Memorandum

Re: Eversource E194 Transmission ACR Maintenance Project
City of Portsmouth Conditional Use Permit

Summary of Changes and Supporting Documentation

MAP SHEET 1 of 3

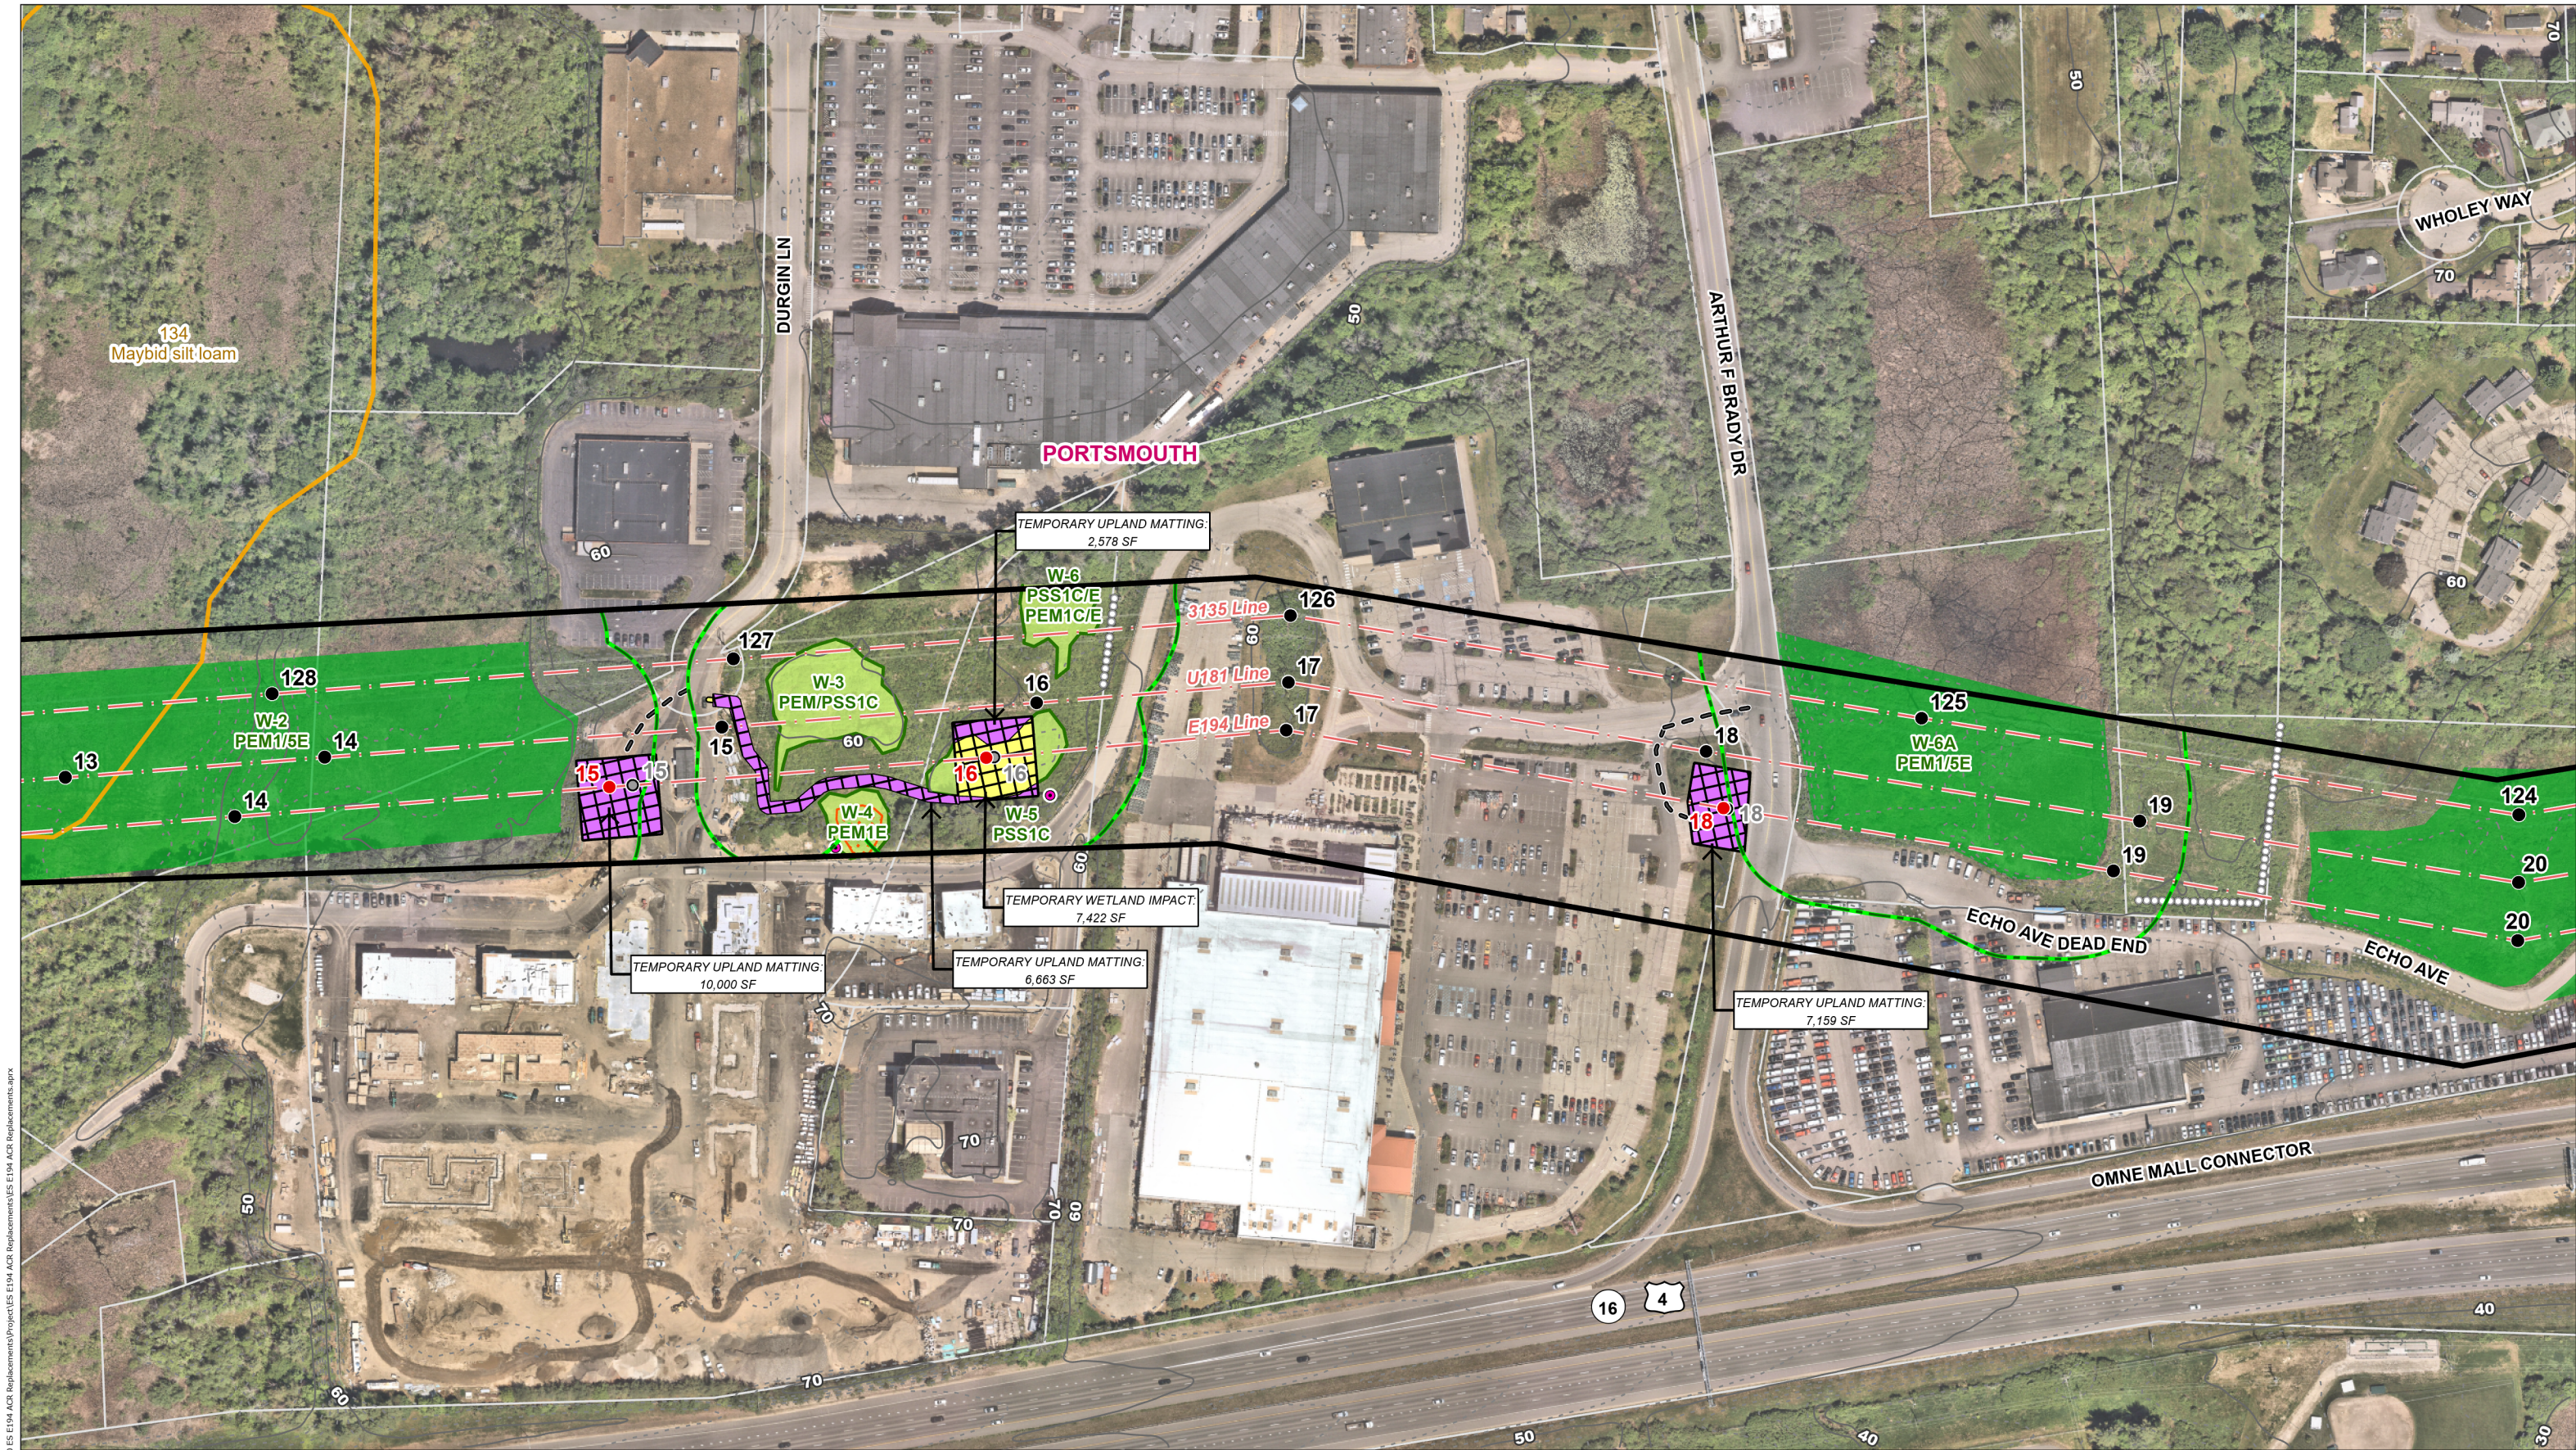
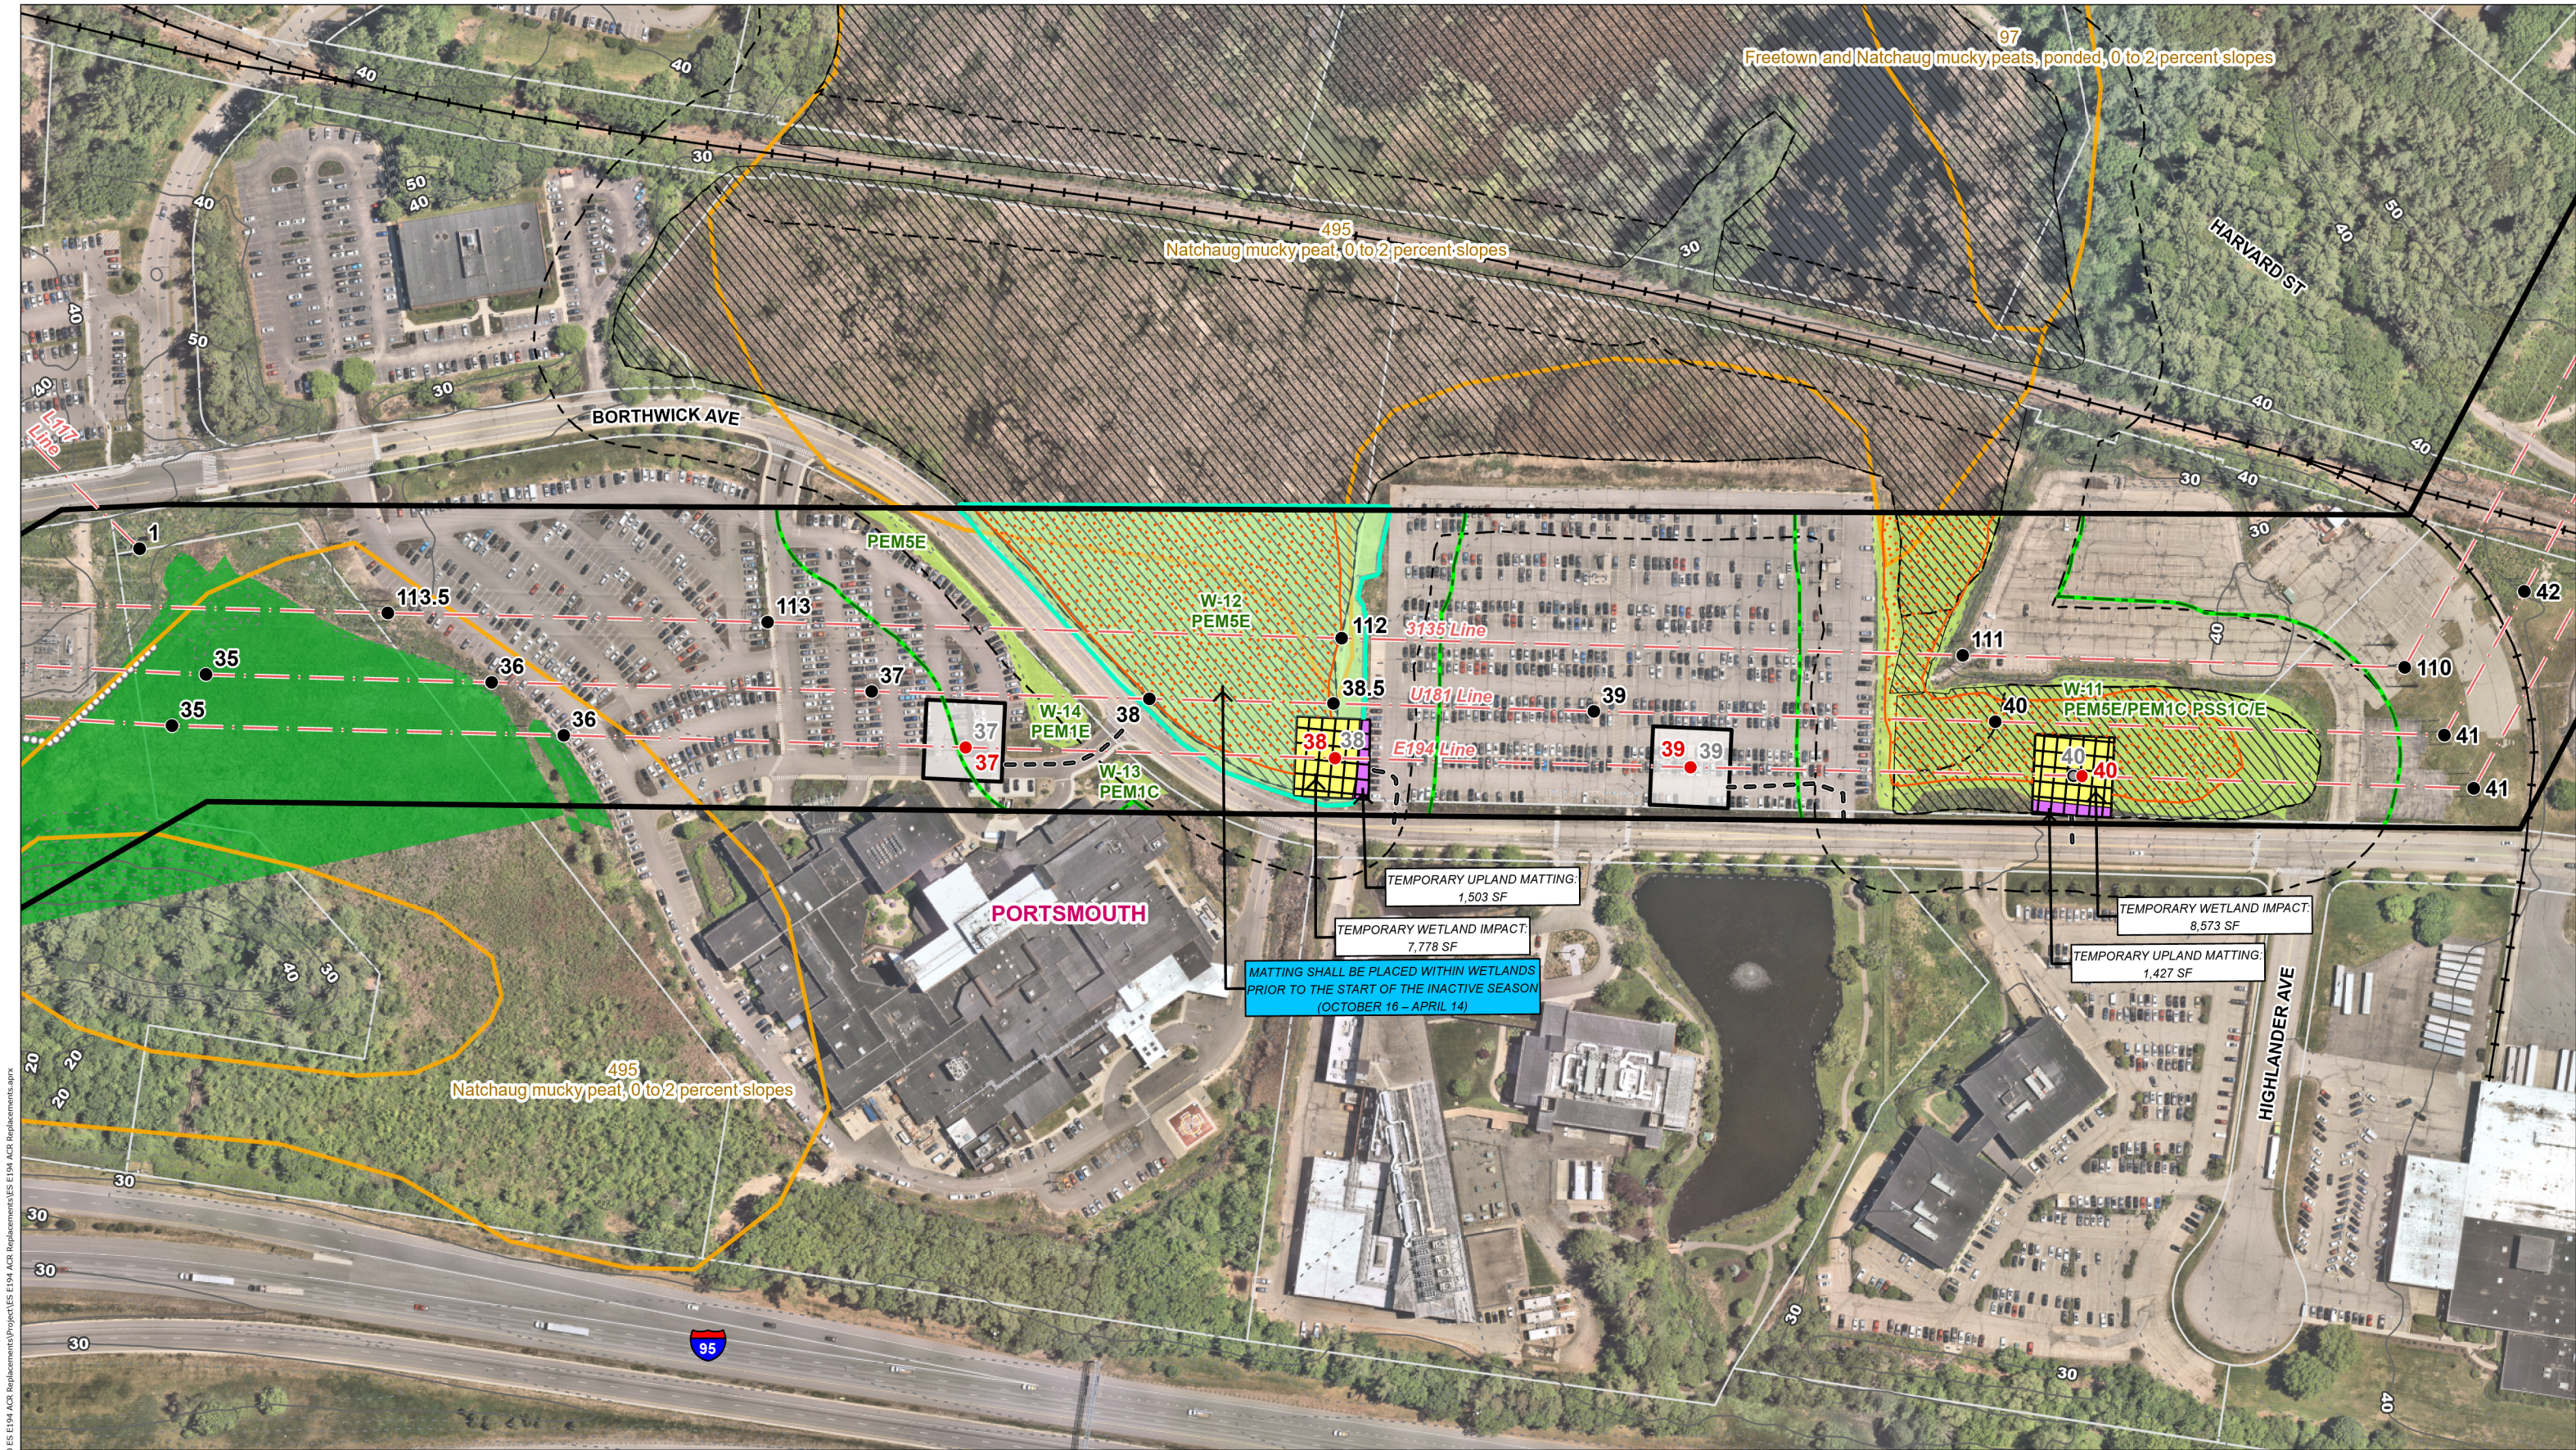
The major revision to the **Project Plans** was to remove the proposed gravel impacts to the wetland buffers, and to depict the temporary upland matting that will be used instead to provide safe and stable access for Eversource and

their contractors to complete the proposed work. Another plan change includes the shift of Structure 15 to be 30 feet back along the line to provide a safe setback from a newly developed roadway.
